STAFF REPORT: 01-22-2020 MEETING

APPLICATION NUMBER: 20-6612

ADDRESS: 8122 KERCHEVAL (aka 8116 - 8130 KERCHEVAL/THE KERCHEVAL 3)

HISTORIC DISTRICT: WEST VILLAGE

NEW FRONT ELEVATION
SCALE - 1/4" = 1'-0"

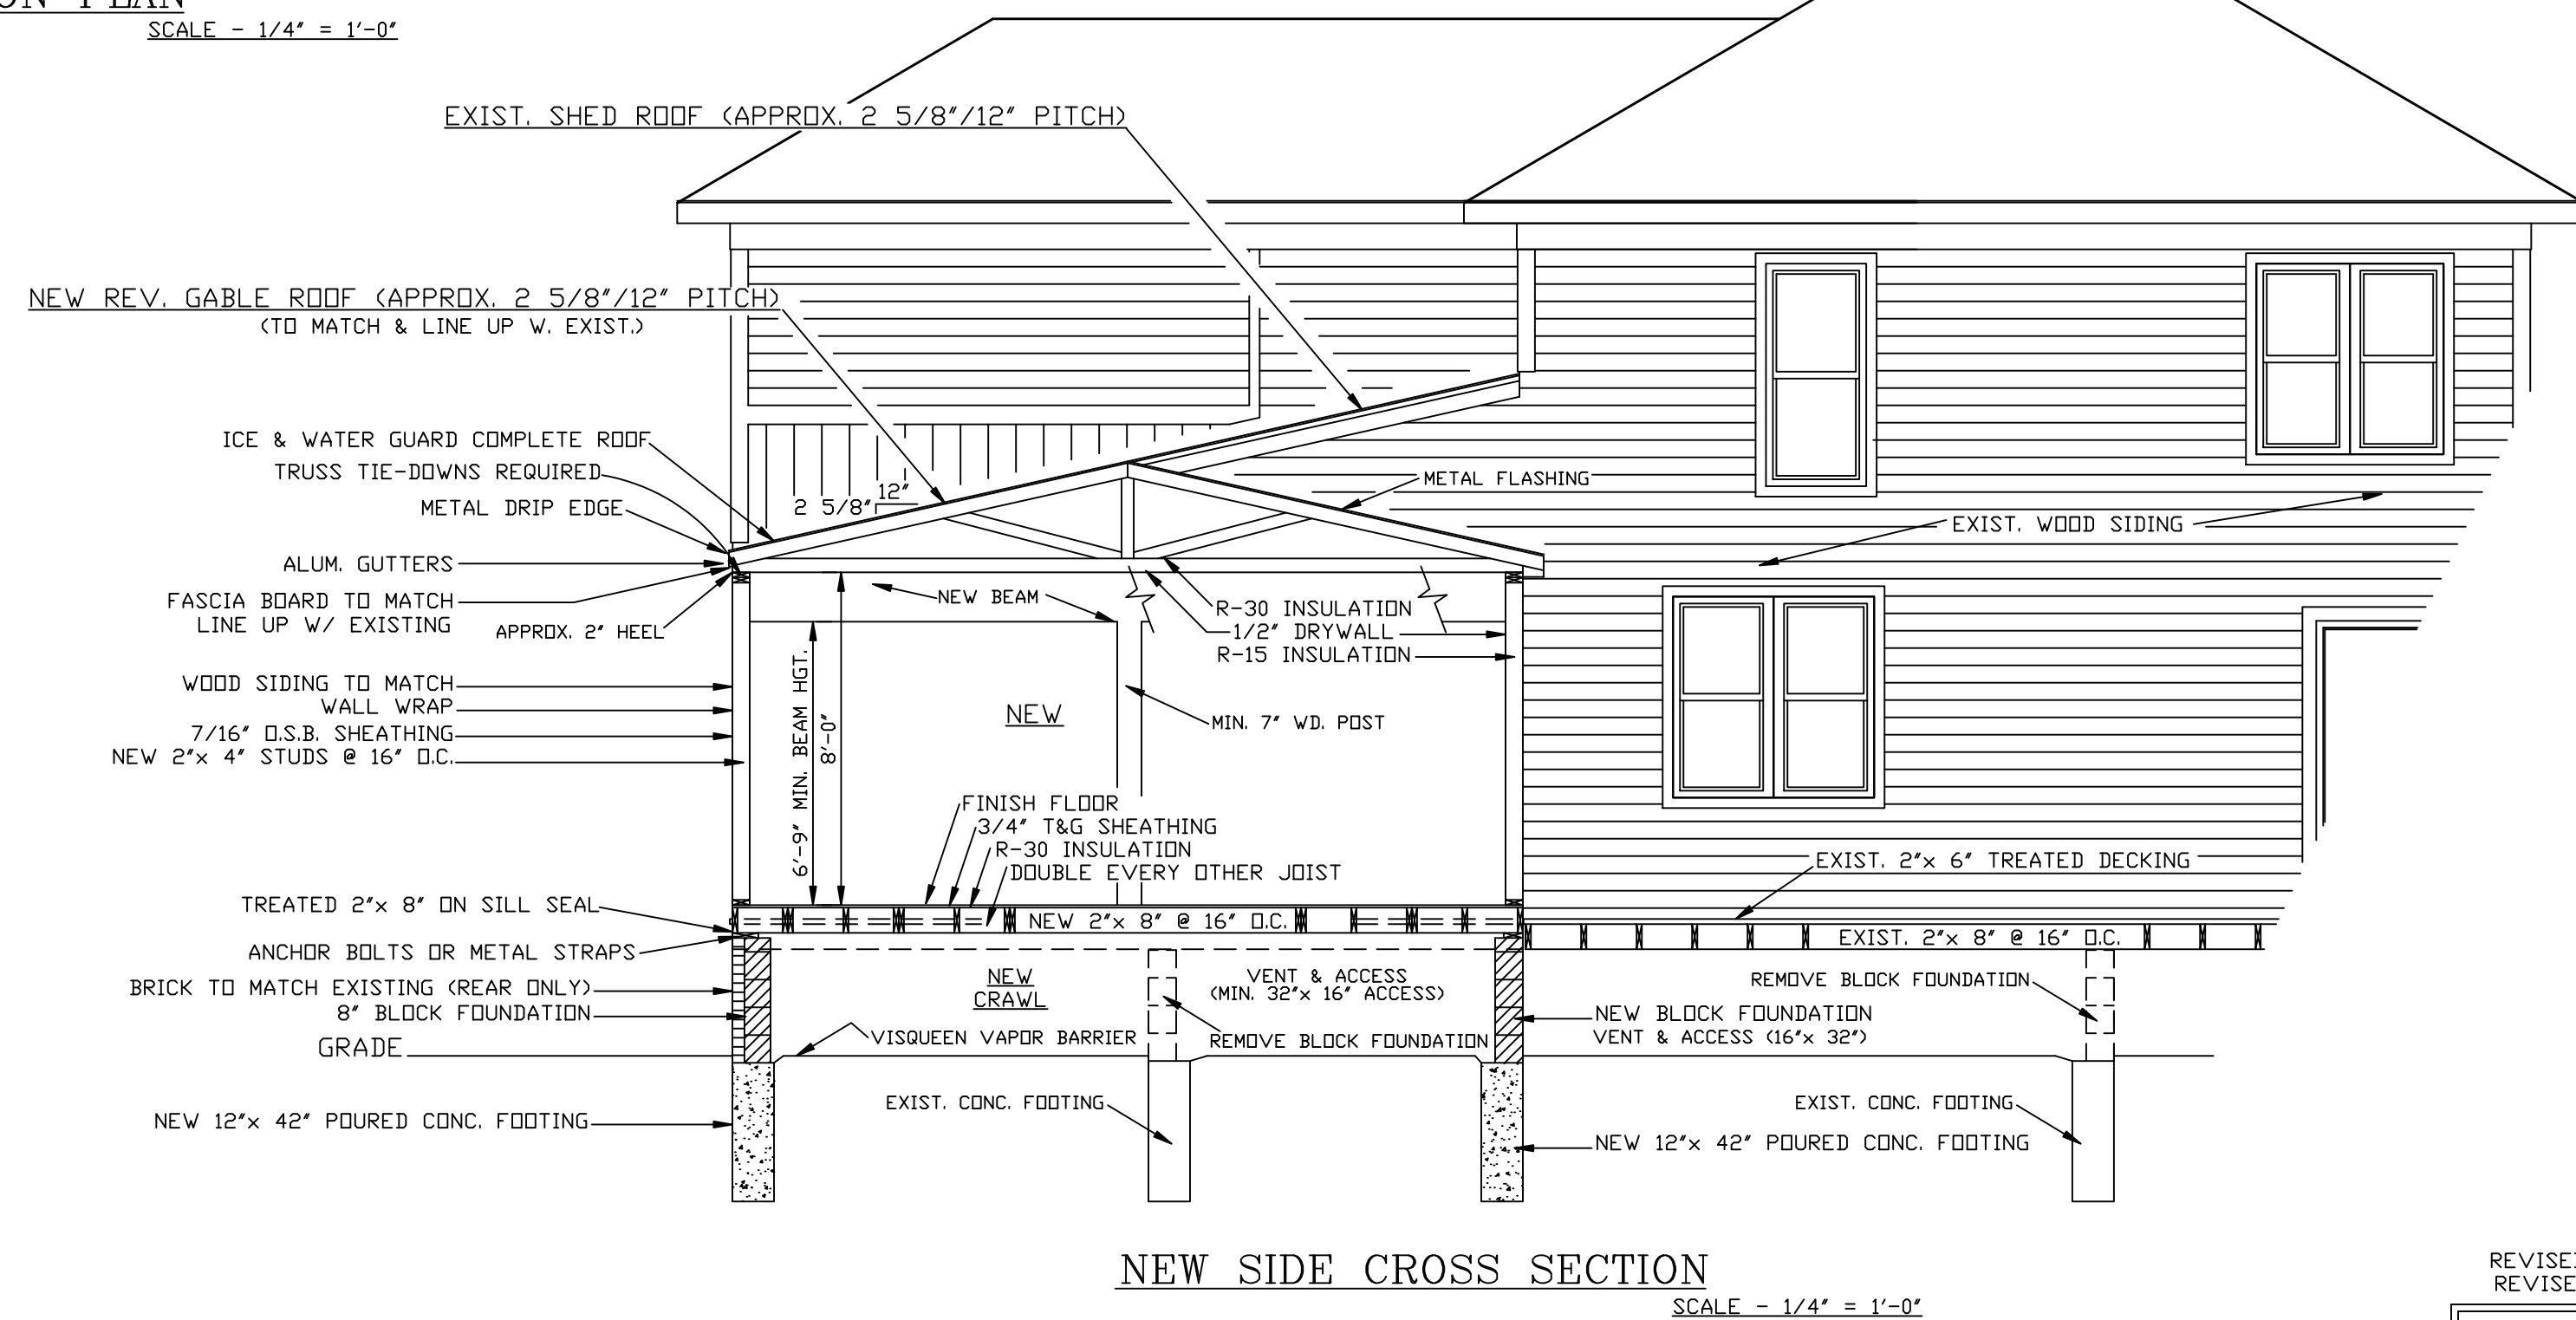
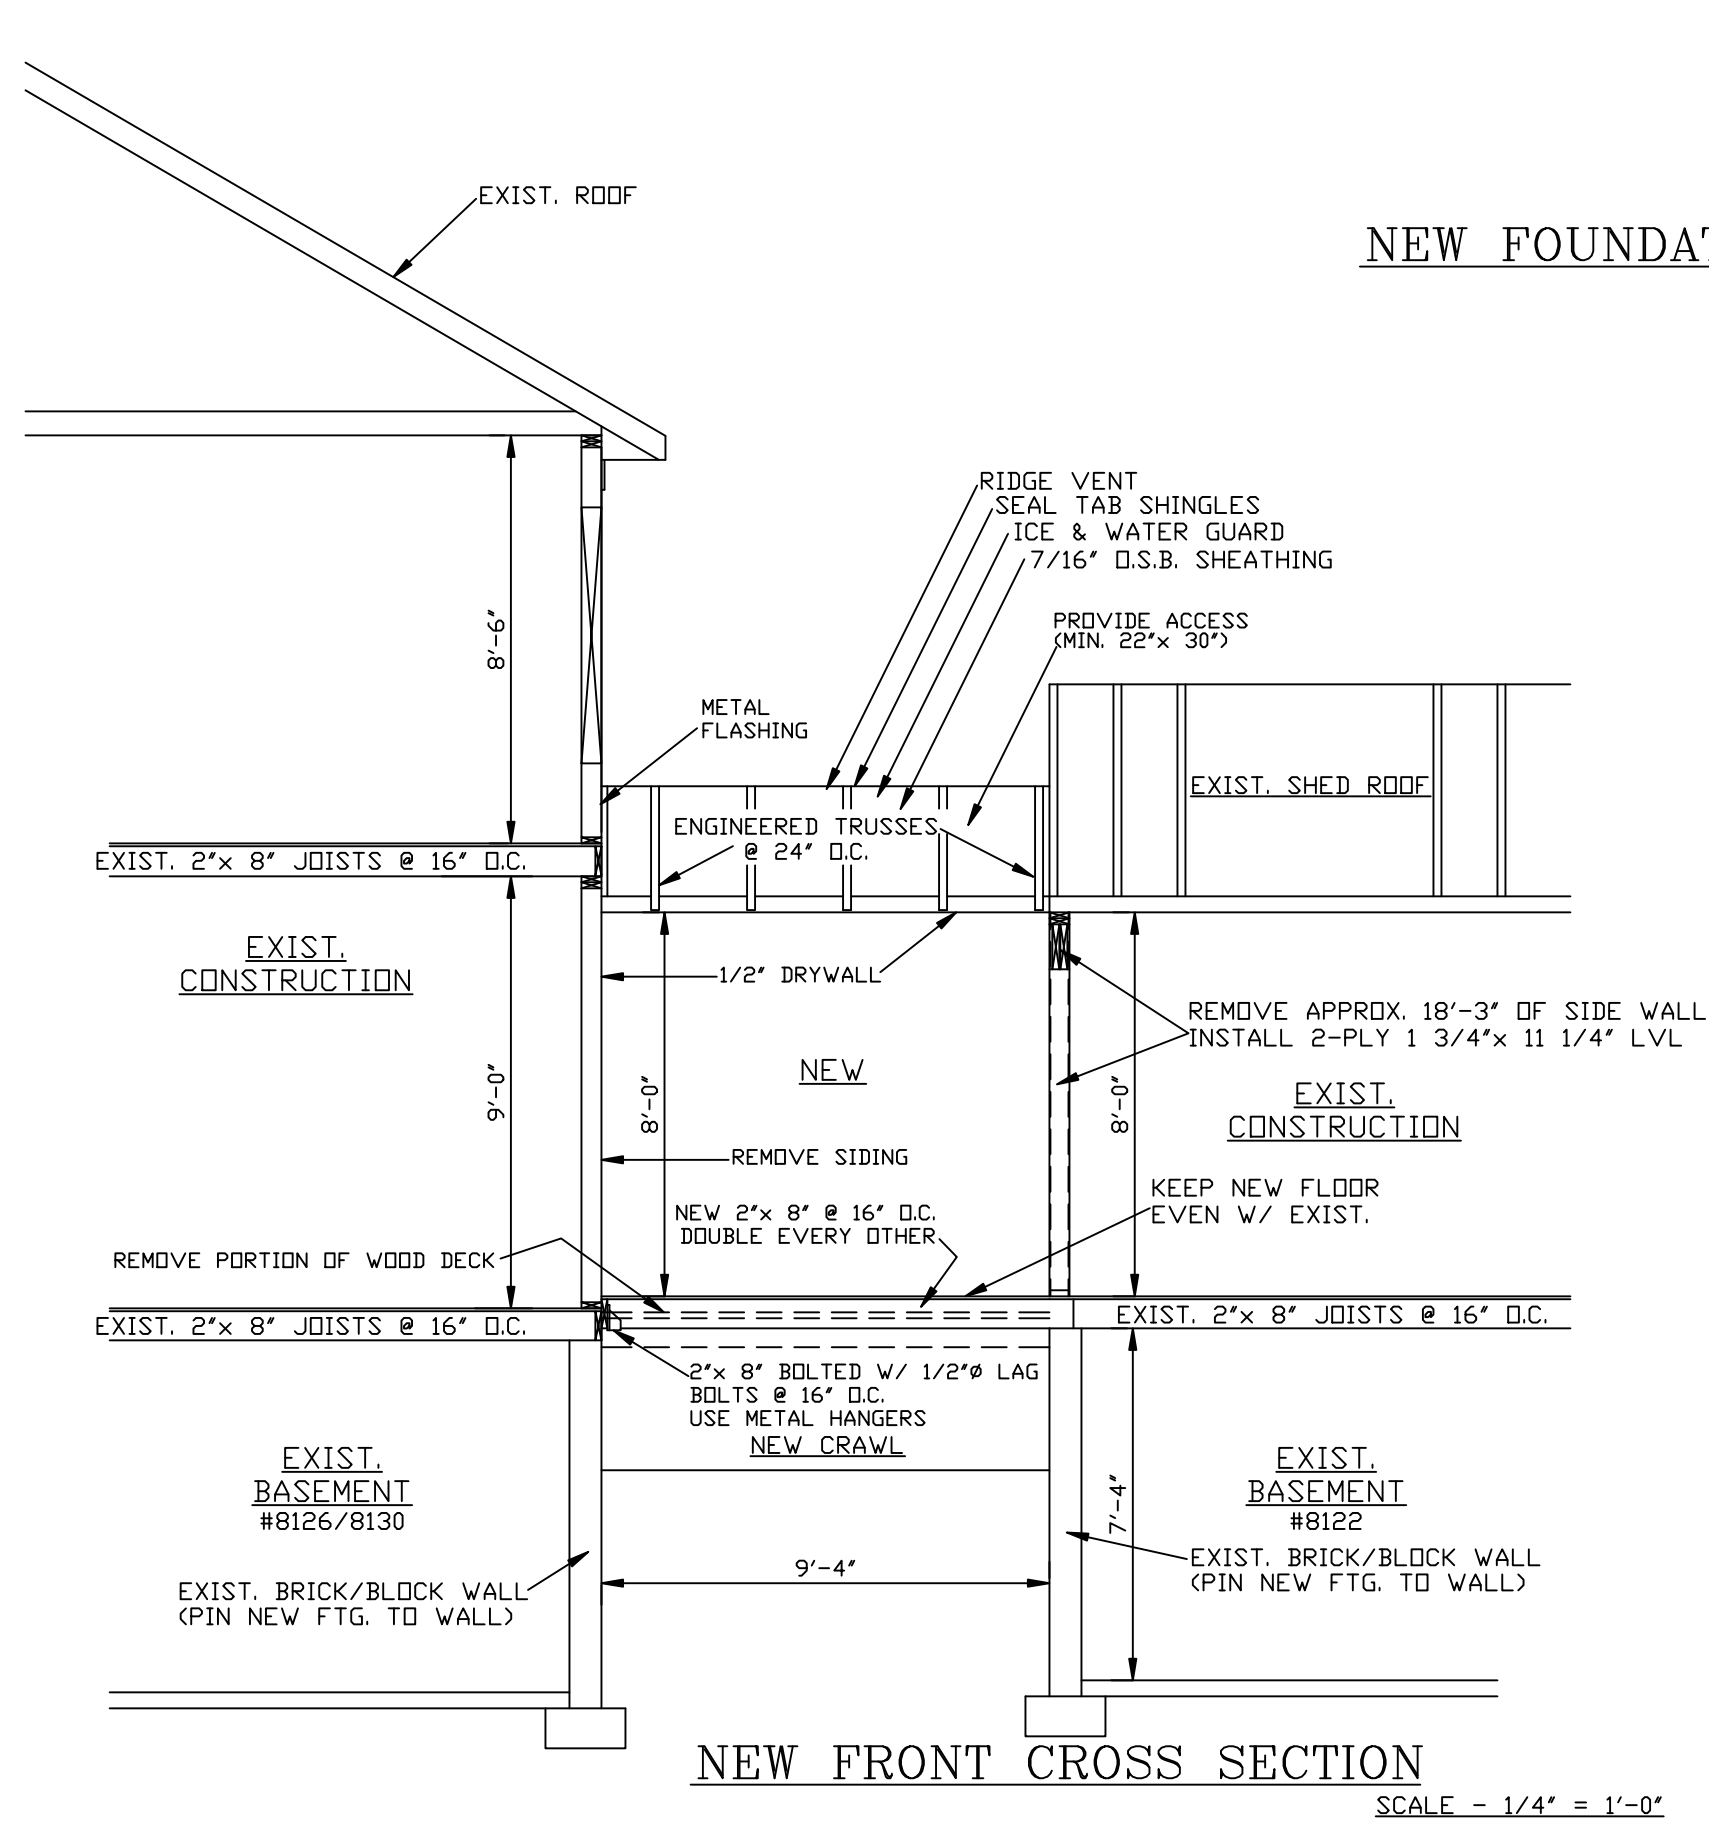
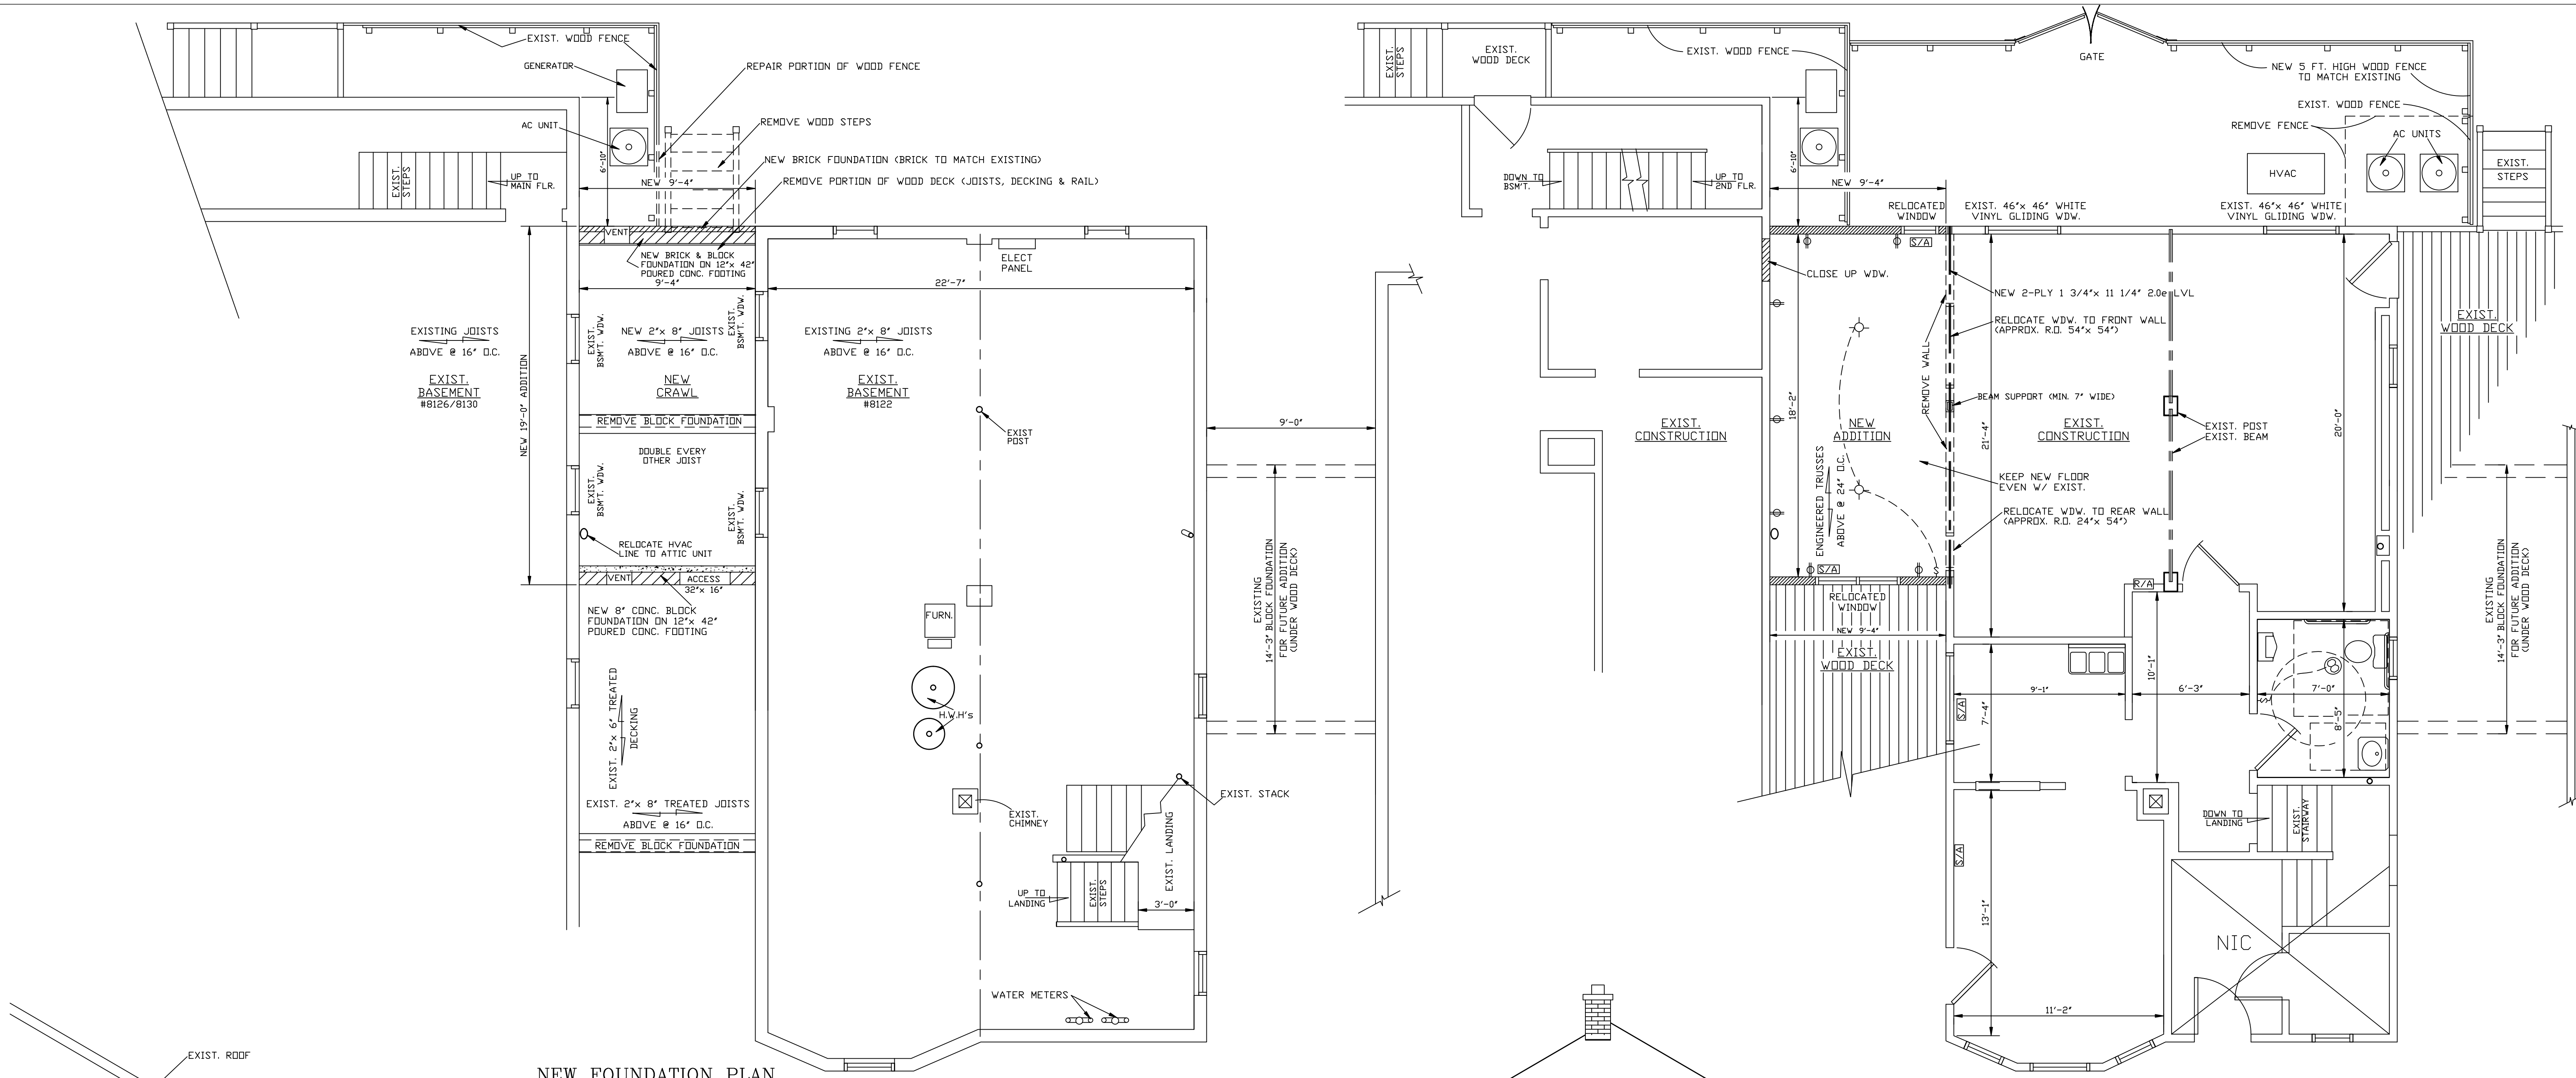
- The fence enclosure on the rear elevation is expansive.
- The two windows installed on the front of the addition are shown as a contemporary ganged double window.

- Painting the wood fencing gray to match the house will help to visually minimize the enclosure, and it shall be painted within one calendar year of the Certificate of Appropriateness.
- A traditional mullion should be constructed for the side-by-side double-hung windows.
- As the existing windows to be relocated are vinyl, wood framed one-over-one windows should be installed. A wood mullion and window casings shall be fabricated for the opening. .

8116 Kercheval – East Elevation

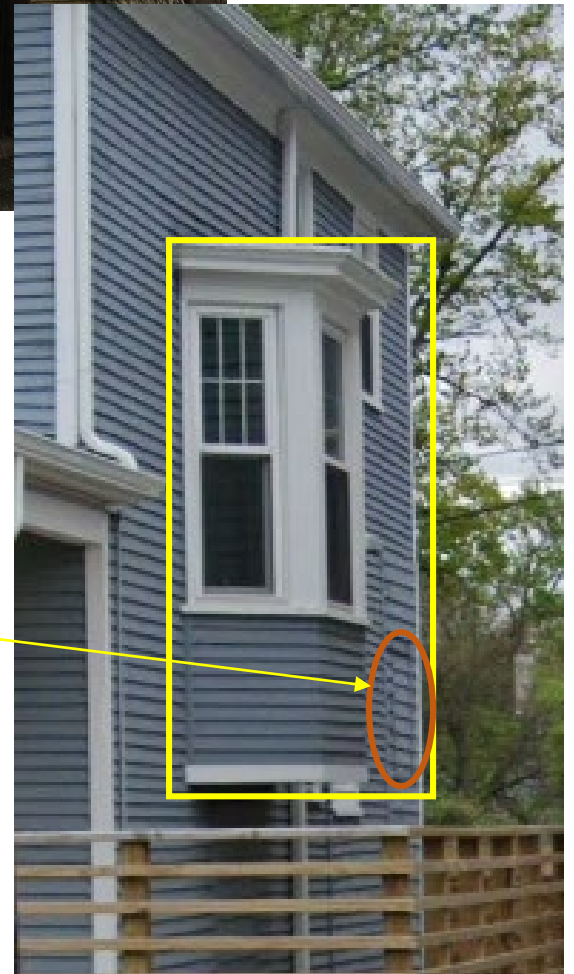
Historic nine-over-one windows still present in 2017.

Replacement windows appear on Google Maps streetviews dated August 2018.

Window on the west elevation covered with wood siding.

Replacement windows are inserts. It looks like the original wood mullions remained and were possibly covered in aluminum.

Three windows on the east elevation of 8116 Kercheval were covered with wood siding. Please refer to the plans from the 2017 review for documentation of the windows.
